BOARD OF COMMISSIONERS

AGENDA *Materials updated 10/14/2021*

Monday, October 18, 2021 - 6:30 pm

- A. Ordinance 2021-09 – (***Adoption***) - Concordia (Eagle and Radnor Rd) – Zoning Map Amendment (*Advertised Public Hearing*)
- B. Resolution 2021-99 - Concordia (Eagle and Radnor Rd) – Request of Preliminary/Final Land Development Plan

RADNOR TOWNSHIP DELAWARE COUNTY PENNSYLVANIA
 SEPT. 15, 2020
SANITARY PROFILES AND CONSTRUCTION DETAILS
 SHEET 12 of 18
 AS NOTED

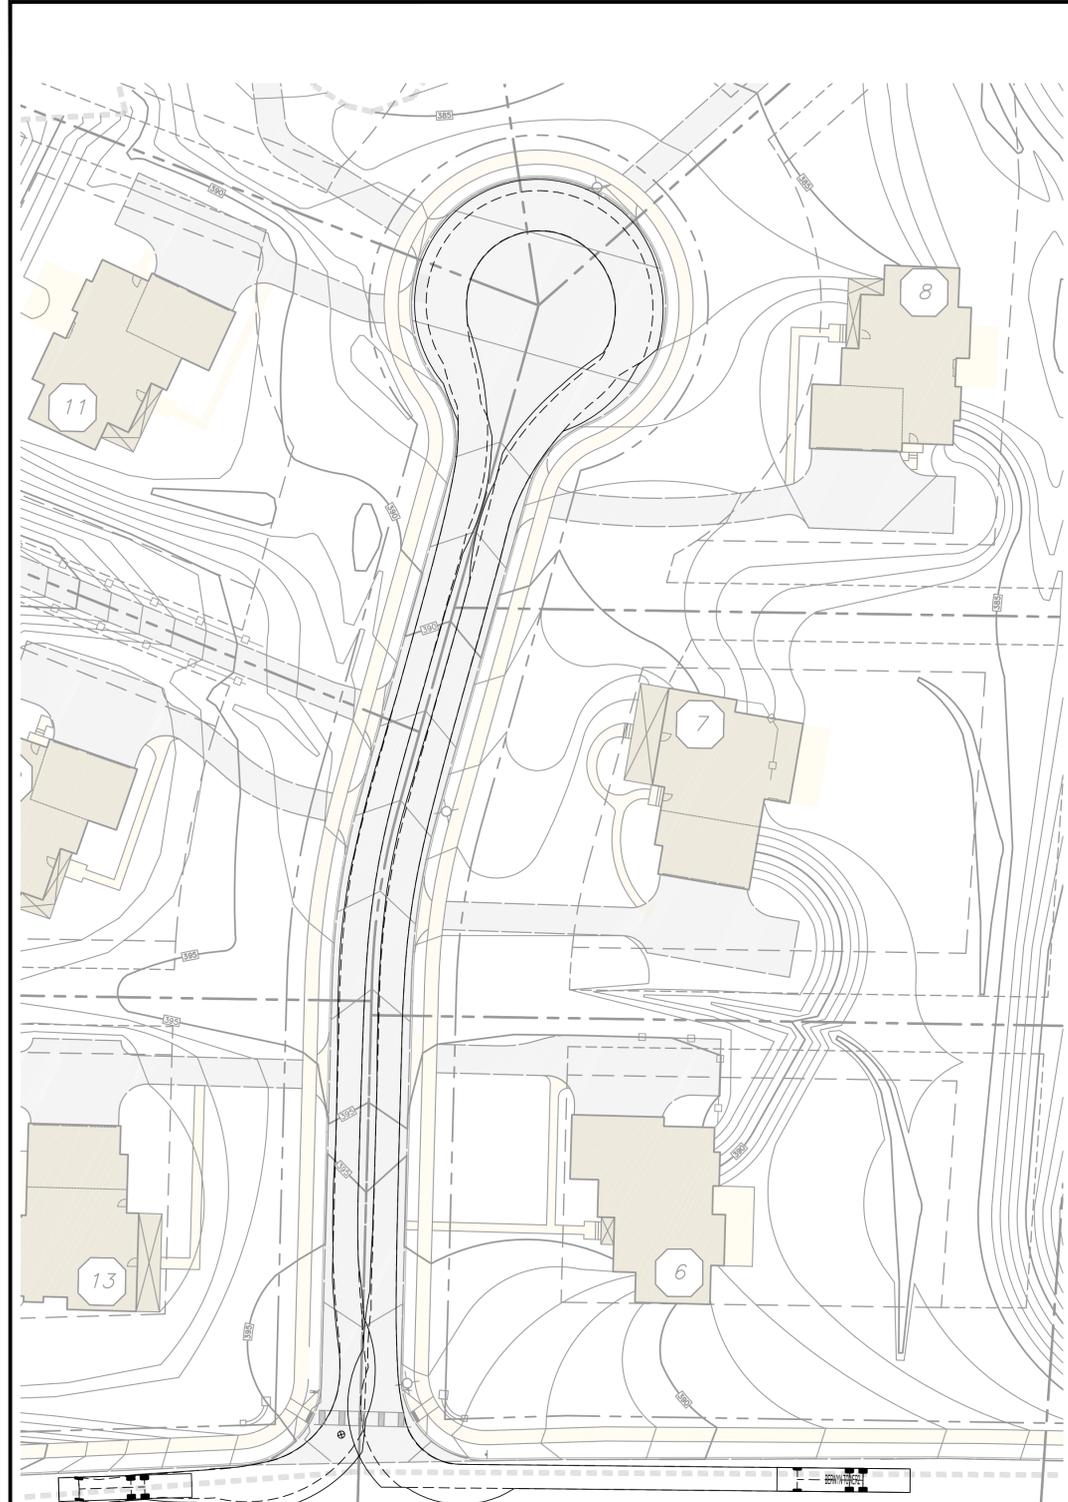
Comment F.5. As previously noted, revise the emergency vehicle turning template to eliminate the curb encroachment along the outer edge of the cul-de-sac bulb. We note the turning template vehicle was not shown on sheet 13 of 18.

Response F.5. The turning template is now shown on Sheet 13 and eliminates any curb encroachment.

SHEET 15 of 18

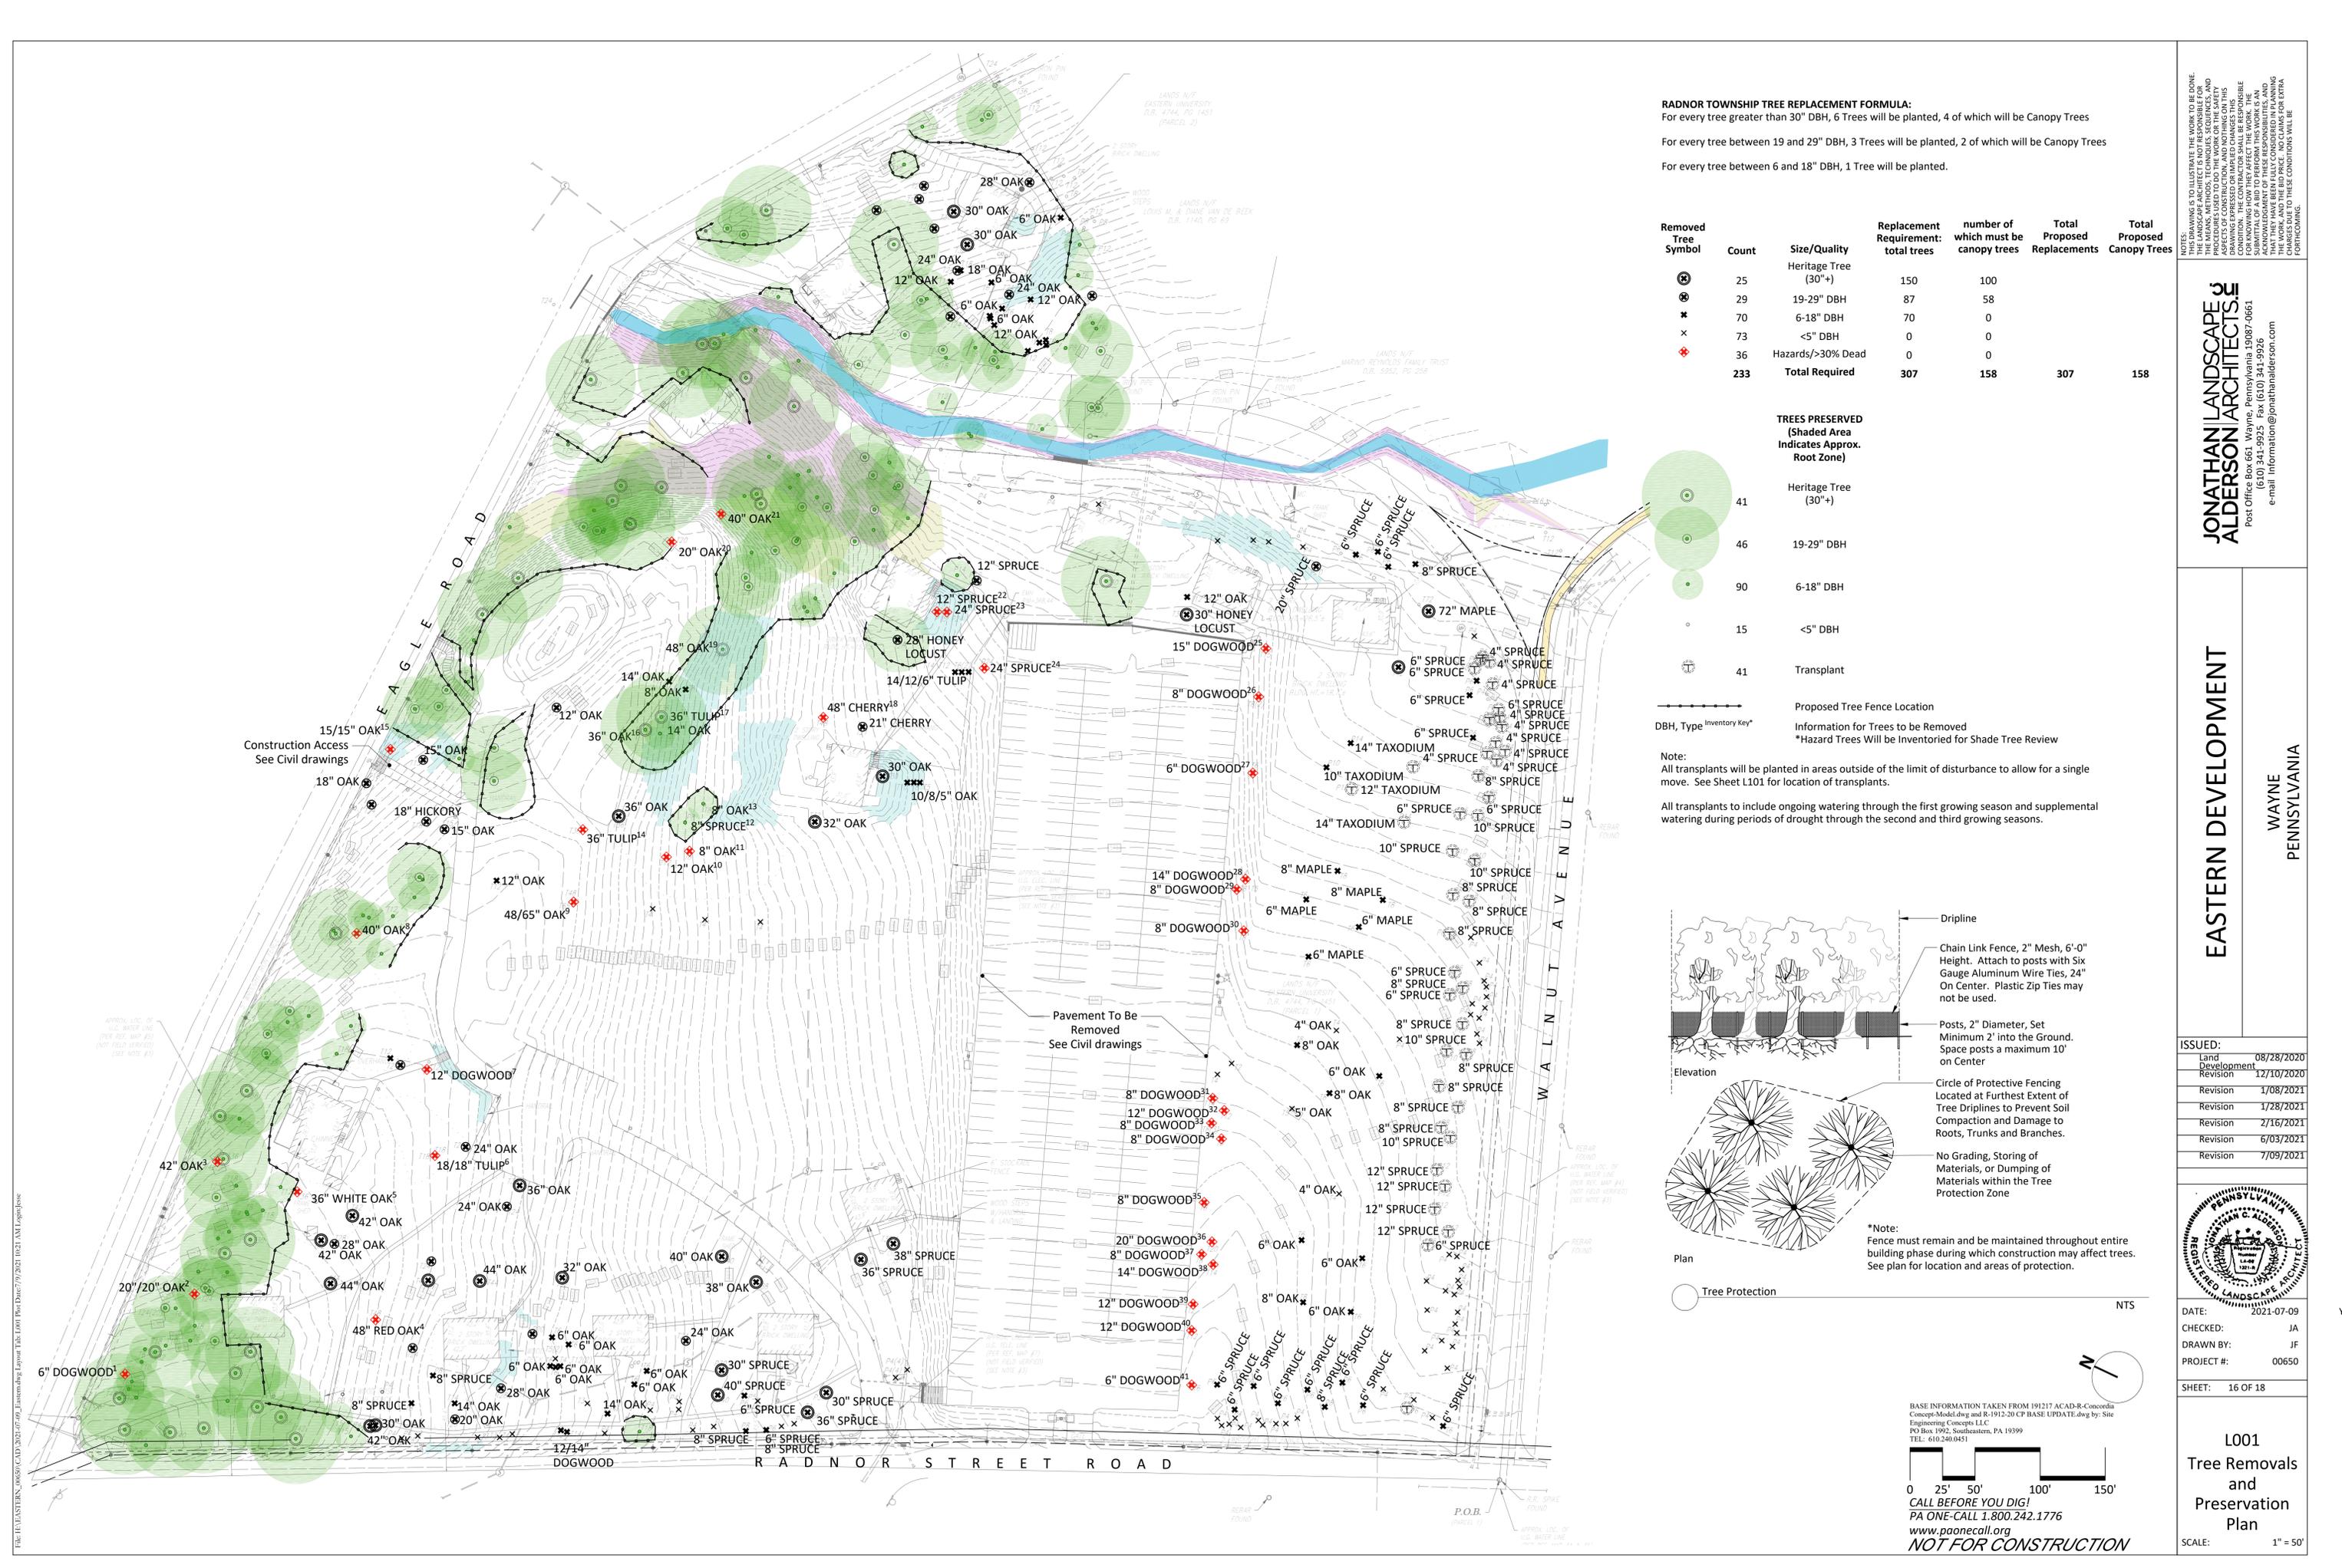
Comment 1. The Post-Construction drainage area map on Sheet 15 of the plan set identifies some drainage areas as Captured Post-Dev Area but they should actually be Post-Dev Bypass Area, specifically some portions of the drainage areas between Lots 16 and 17, and between Lots 17 and 10. Please revise the drainage areas to accurately reflect the conditions shown and ensure that drainage boundaries and hatches are consistent.

Comment 2. The Post-Bypass Total hydrograph in the stormwater report indicates a drainage area of 4.741 ac but the Post-Construction drainage area plan on Sheet 15 of the plan set appears to indicate a Post-Dev Bypass area of ~5.45 ac. Please revise this inconsistency.

Comment 1. The proposed drainage area map on Sheet 15 of the plan set has several instances where the drainage boundaries and the drainage area hatches do not align. Additionally, some of the drainage areas are indicated as Captured Post-Dev Area but they should actually be Post-Dev Bypass Area, and vice versa. Revise the drainage areas to accurately reflect the conditions shown and ensure that drainage boundaries and hatches are consistent.
